Project: LAND TO THE EAST OF THE FORMER TAMWORTH GOLF COURSE, TAMWORTH

D. Stage 1 Road Safety Audit & Designers Response

STAGE 1 ROAD SAFETY AUDIT

Road Safety Audit Response Report

Project Originator | Functional | Spatial | Form | Discipline | Number | Revision
15596-WIE-HGN-ZZ-DR-C-950102 P02

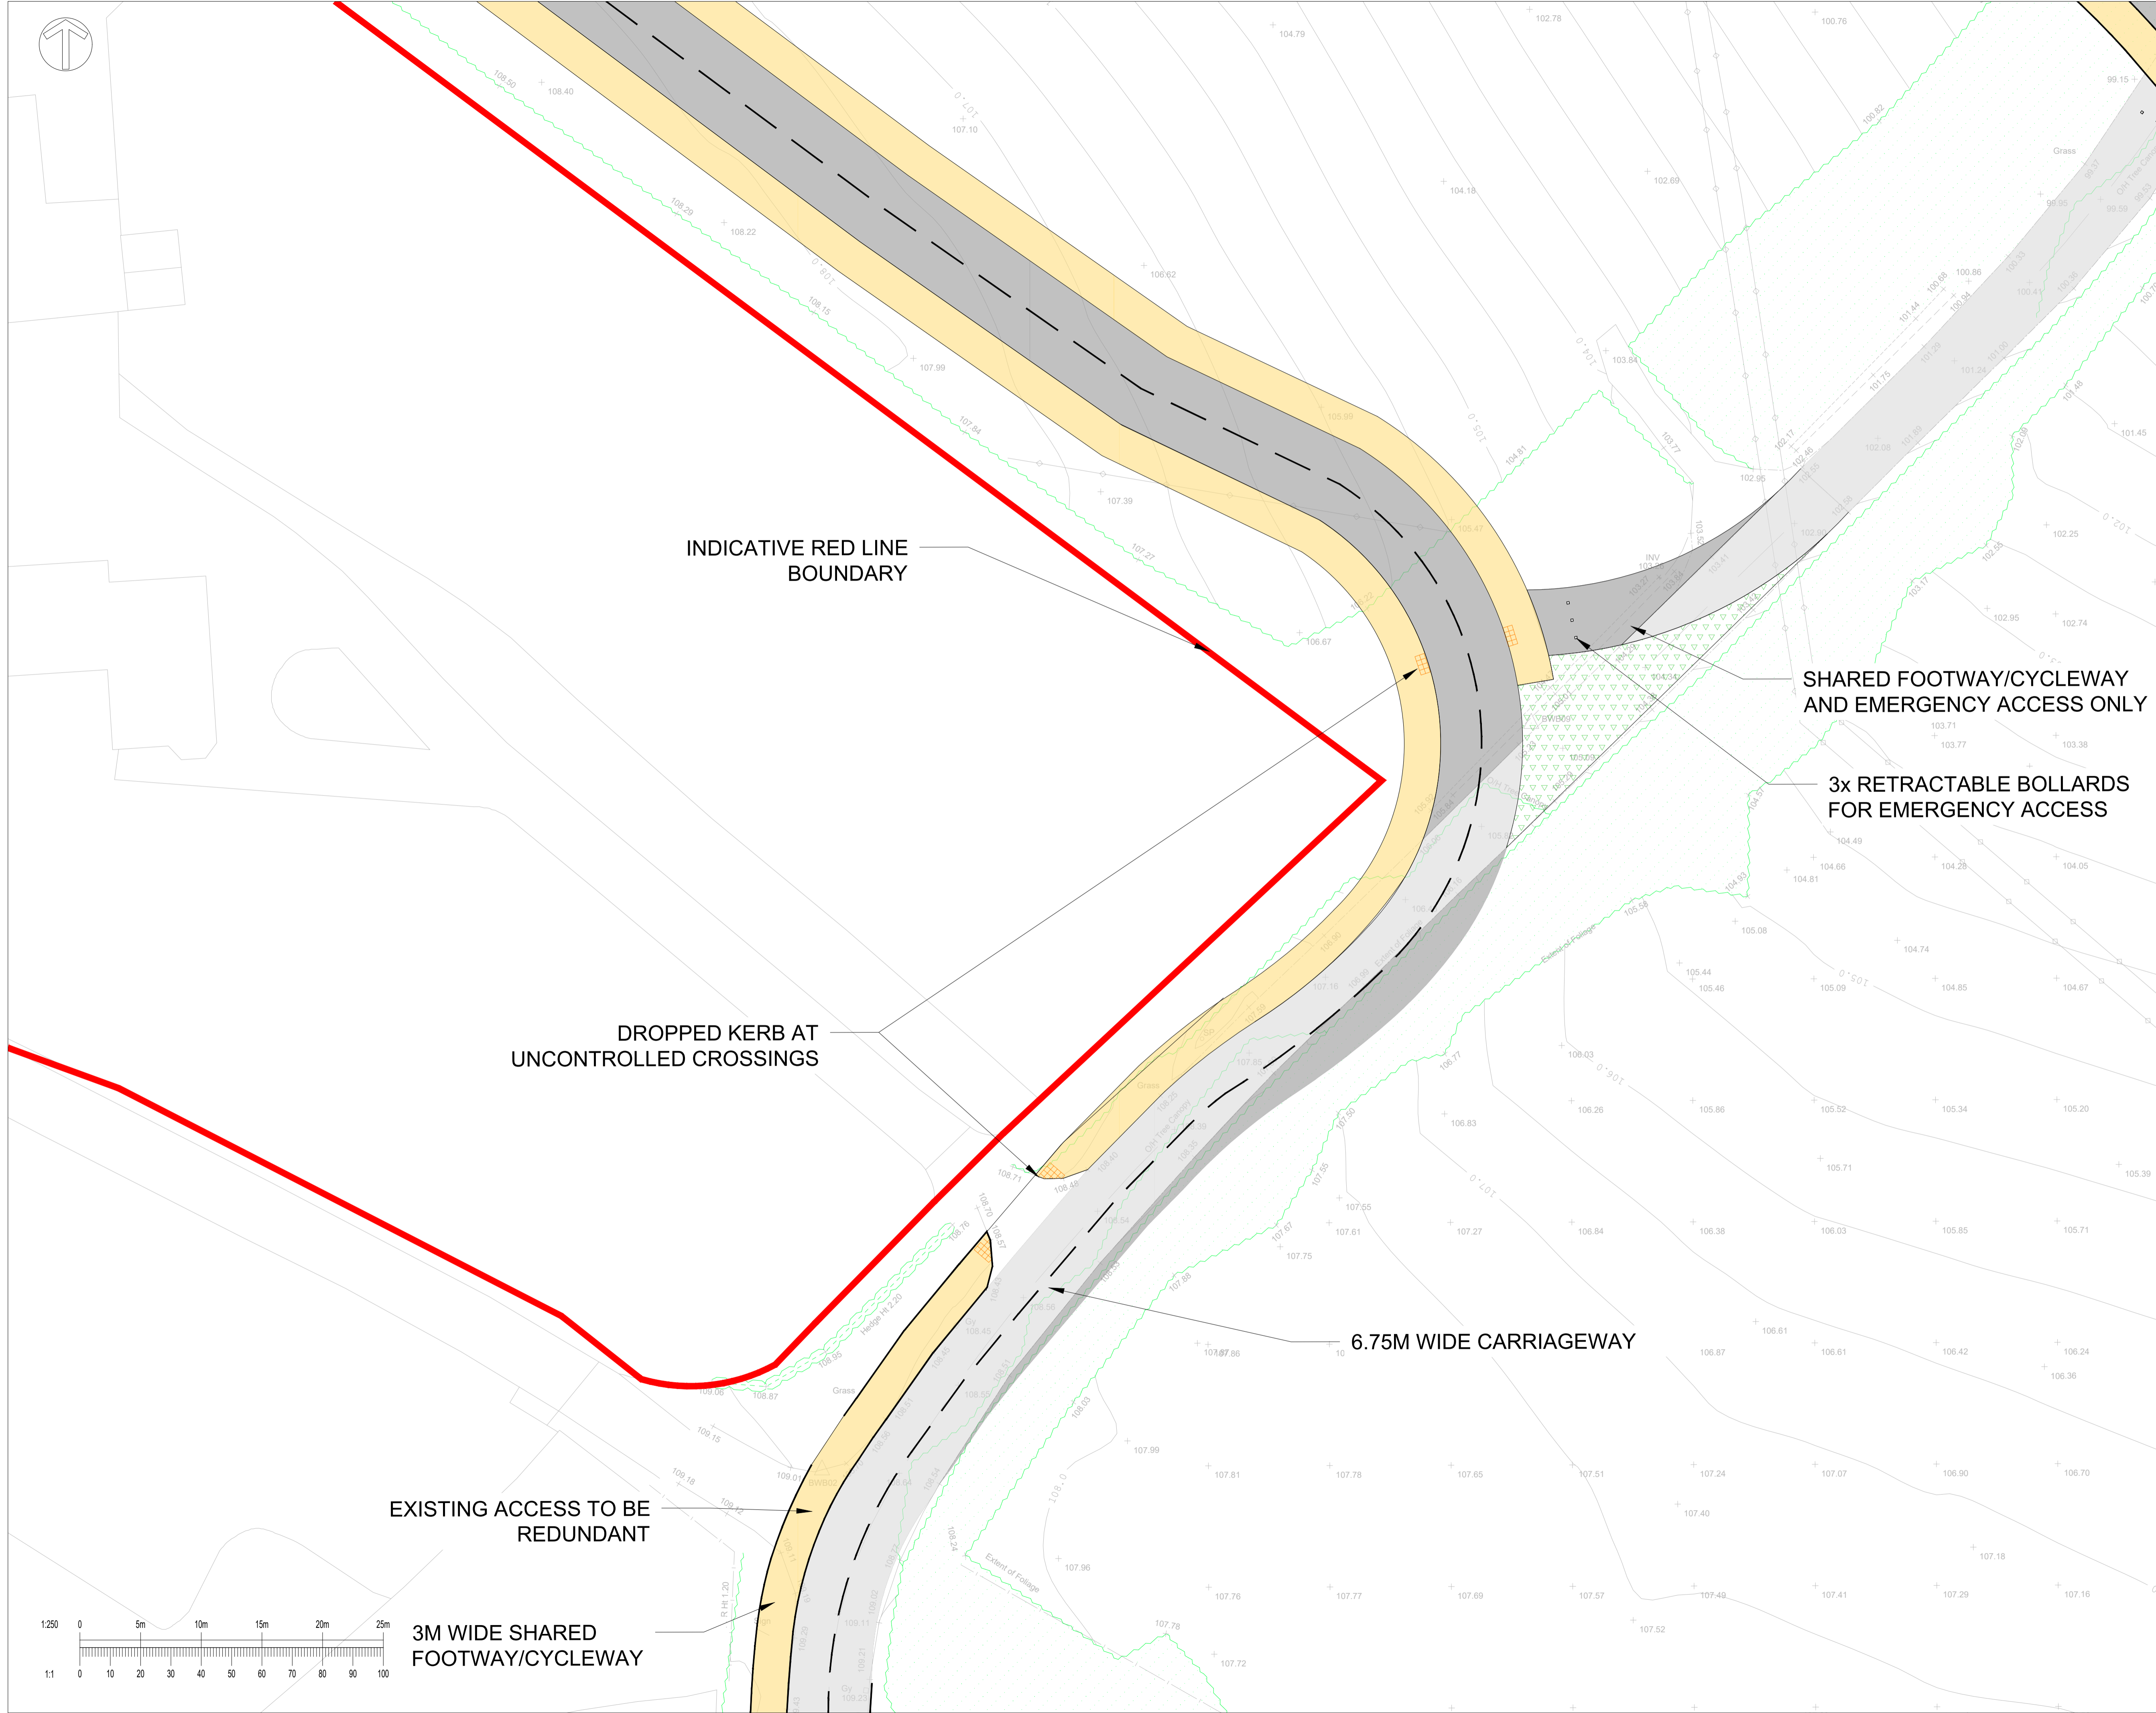
<p>Problem 7.4 No swept path analysis has been provided to the Audit team. The left turn out of Robey's Lane appears to be tight past the central island. If insufficient it could lead to larger vehicles striking the island and in turn the signal equipment, guard railing or pedestrians on the island.</p>	<p>It is recommended that vehicle swept path analysis is carried out to ensure vehicles can make all manoeuvres at the proposed junction</p>	<p>Vehicle tracking has been undertaken which demonstrates there to be sufficient space for the appropriate design vehicles to enter, exit and manoeuvre along all road and junctions. Drawings illustrating the vehicle swept paths include 15596-WIE-HGN-XX-DR-C-050102-P02 and 15596-WIE-HGN-XX-DR-C-050107-P02</p>		
<p>Problem 7.5 The proposed closure of a section of Robey's Lane close to Priory Park results in the creation of a sharp left bend into the development site / field to the west. If a driver unfamiliar with the changes were to proceed down Robey's Lane at speed, there is a risk that they could attempt to go straight on along the old alignment of the road resulting in them overshooting the bend and leaving the carriageway.</p>	<p>It is recommended that measures be included within the design to ensure the potential hazard posed by the road realignment is made obvious to all drivers and mitigated</p>	<p>The layout has been revised to avoid the see-through effect with the old alignment. See Drawing 15596-WIE-HGN-ZZ-DR-C-950102-P02 in Transport Assessment Addendum Appendix C</p>
